**From:** Dana Siegfried  
**To:** John White  
**Date:** Wed, Nov 9, 2005 2:42 PM  
**Subject:** Re: Fwd: Klondike III Wind Power Project

Response to Kerrie Standlee Comments on Exhibit X	
Comment No.	Comment and Response
1	<p>It is stated on page X-5 of Exhibit X and again on page 8 of the TW Environmental, Inc. report in Appendix X-1 that a maximum sound power level of 106 dBA was used in predicting the noise that would radiate from the Klondike III project (104 ± 2 dBA). However, on those same pages, the maximum octave band sound power level data presented as representative of the data supplied by GE summed up to only 104 dBA. After running some preliminary calculations of my own, it appears to me that the 104 dBA octave band data may have been used in the calculations instead of 106 dBA octave band data. We need to know if octave band data summing up to 106 dBA was used in the analysis of if those octave band data shown in Exhibit X were used in the analysis. If octave band data summing up to 106 dBA was used in the analysis, we need to see that data.</p> <p><b>TW Response:</b> The sound power data supplied by GE and used in the analysis sums to 104 dBA. The statement that 10

## Sound Power Levels for Vestas V82-1.65 MW Turbine

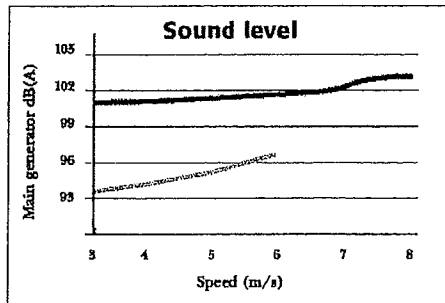
2	<p>In your "request for additional information" question X4, you requested documentation of the sound power level for the GE and Vestas turbines over the entire range of wind speeds from "cut-in" to the "wind speed corresponding to the maximum sound power." The response provided by the applicant stated that the sound power data from the GE turbines ranges from less than 96 ± 2 dBA at a wind speed of 3 m/s to less than or equal to 104 ± 2 dBA at a wind speed of 7 m/s (cut-out). The applicant stated that documentation for the GE turbines was not provided because the data explicitly states that it is confidential and can not be copied without written consent from GE Energy. Finally, the applicant stated that the Vestas data was available but it was not provided because the GE data was considered to be more conservative and was used in the analysis.</p> <p>The data you requested is needed for our review because it is needed to determine the wind speed at which the noise from the turbines would first begin to exceed the 36 dBA ambient degradation criteria at all residences in the area. The applicant has shown that, at cut-out wind speed, the GE turbines would generate noise levels that exceed the 36 dBA limit at four residences but they implied that such an event would rarely occur. The DEQ noise regulation for wind turbines states that the noise generated by a wind facility shall not cause an increase of more than 10 dBA in the ambient noise at any residence over the entire range of operating wind speeds. Based on what little information the applicant has provided, it appears that the GE turbines will generate noise levels that exceed the 36 dBA criteria at some of the residences at wind</p>

speeds close to the cut-in wind speed. We therefore request that either the applicant request written consent from GE Energy to supply the sound power data for the GE turbine or the applicant provide the wind speed at which the sound generated by the GE turbines will first exceed the 36 dBA criteria at the four residences identified in their report as experiencing noise levels above the criteria when the wind speed was at cut-out speed. Since it is possible that the applicant will be using the Vestas turbines instead of the GE turbines, and because we also need to determine the wind speed at which the Vestas turbines will initially begin to generate noise levels that exceed the 36 dBA level at residences around the area, the applicant should provide the sound power data for the Vestas turbines as you requested.

**TW Response:** GE sound power data are shown in the attached table. Please note that this information is considered confidential business information and GE has authorized its release to permitting agencies only. (This data should be protected by the Oregon Department of Energy pursuant to ORS 192.501(2) and 192.502(4), as well as other applicable law.) Vestas sound power data are shown in the attached figure. Wind speed data at an 80-meter tower height are included in the attached table.

It appears there was a misinterpretation of the GE data where the notation 9 – cut out was interpreted to mean that 9 m/s was the cut out speed. However, the correct interpretation appears to be from 9 m/s to the cut out speed of 20 m/s. Based on a GE calculation, 9 m/s at hub height correlates to 7 m/s at a 10 meter tower height (referenced in the TW Environmental, Inc. report) with certain assumptions. These assumptions are not needed as the attached wind speed data are for an 80 meter height. The highest sound level predicted at a receiver is 41 dBA at R6. To maintain sound levels below 36 dBA (a 10 dBA increase over 26 dBA), the contribution from the turbines at R6 cannot exceed approximately 35 dBA, or 6 dBA less than at maximum sound levels. The GE data indicate that this condition would be met at hub height wind speeds of between 6 and 7 m/s (13.4 to 15.6 miles per hour). These hub height wind speeds would be expected to correlate to surface wind speeds over 10 miles per hour. Ambient sound levels without the turbines are not likely to be as low as 26 dBA at surface wind speeds over 10 mph.

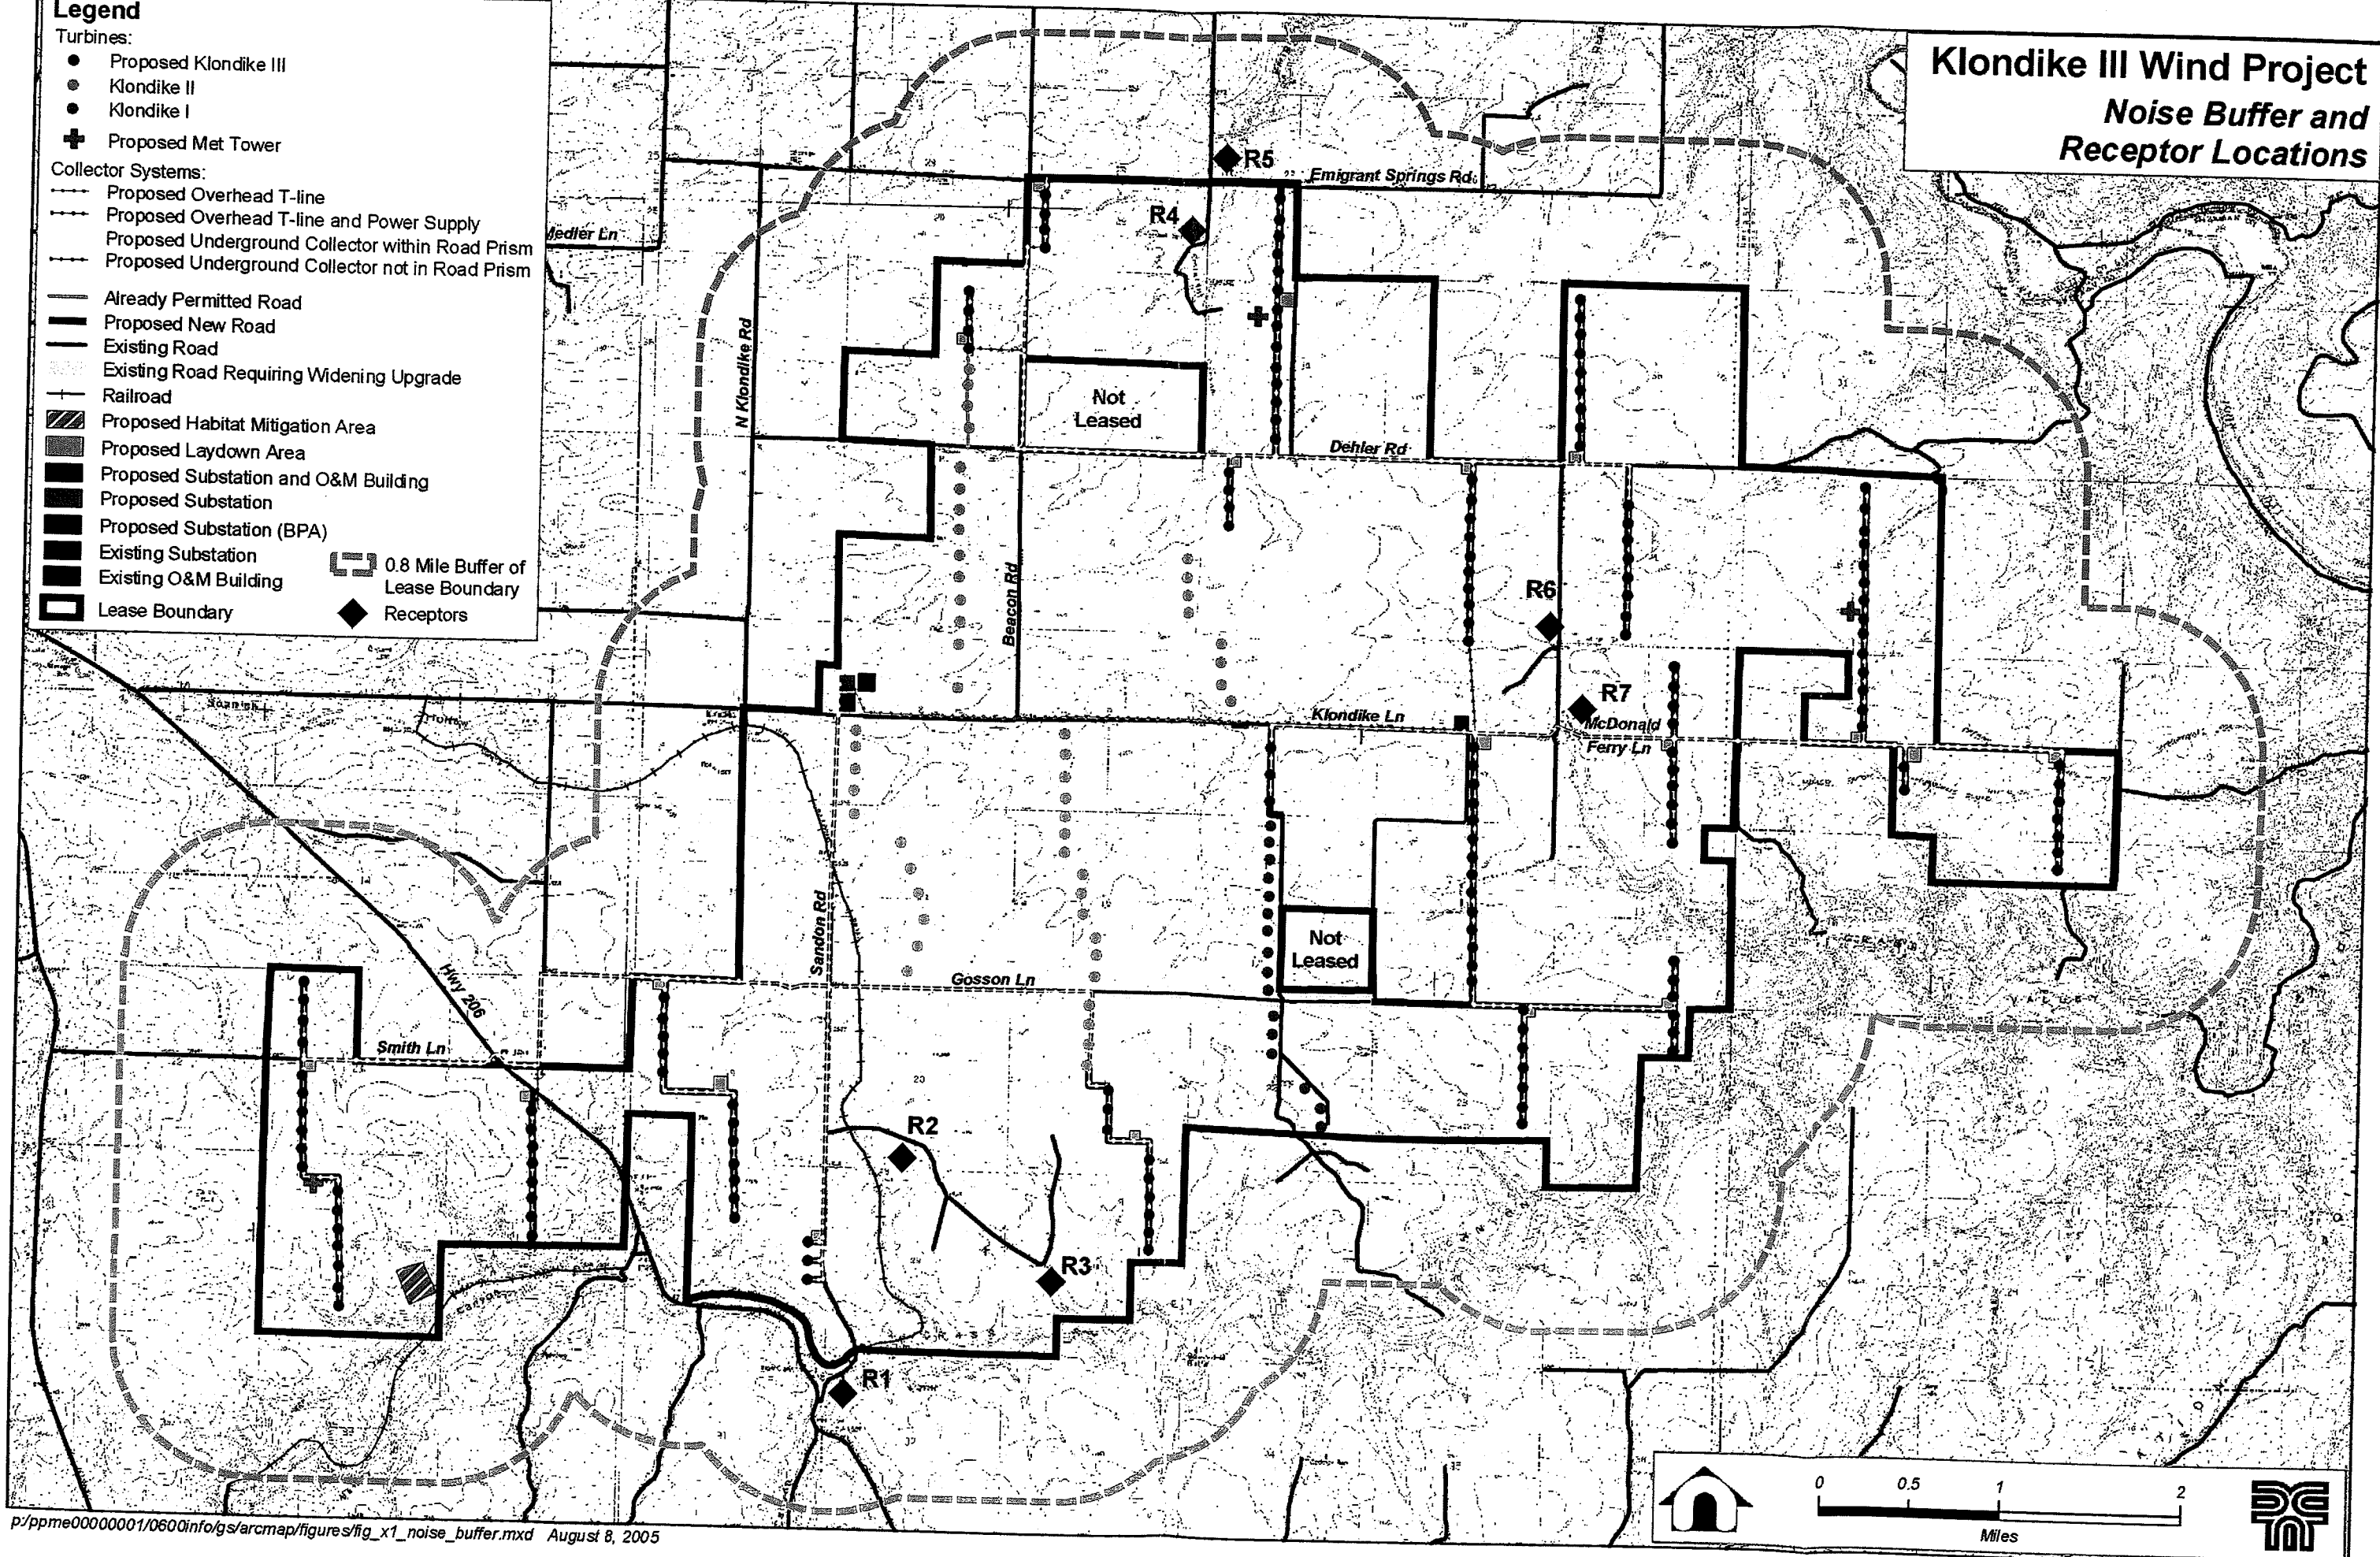
2. The application supplement that you prepare to "complete" the application should include a map or set of maps to illustrate your proposal regarding turbine corridors. You have provided a spreadsheet (string\_ends\_110705.xls) to define the endpoints of turbine corridors. I could not figure out the logic that drove the order in which these points are listed on the spreadsheet, but I rearranged the list to pair the north and south endpoints of each string, based on the Turbine Location Map (Appendix C-3). I then assigned letters to each string, starting with the west side of the project (Wpt1) and working east. I have attached the resulting spreadsheet (JW\_string\_ends\_110705.xls).
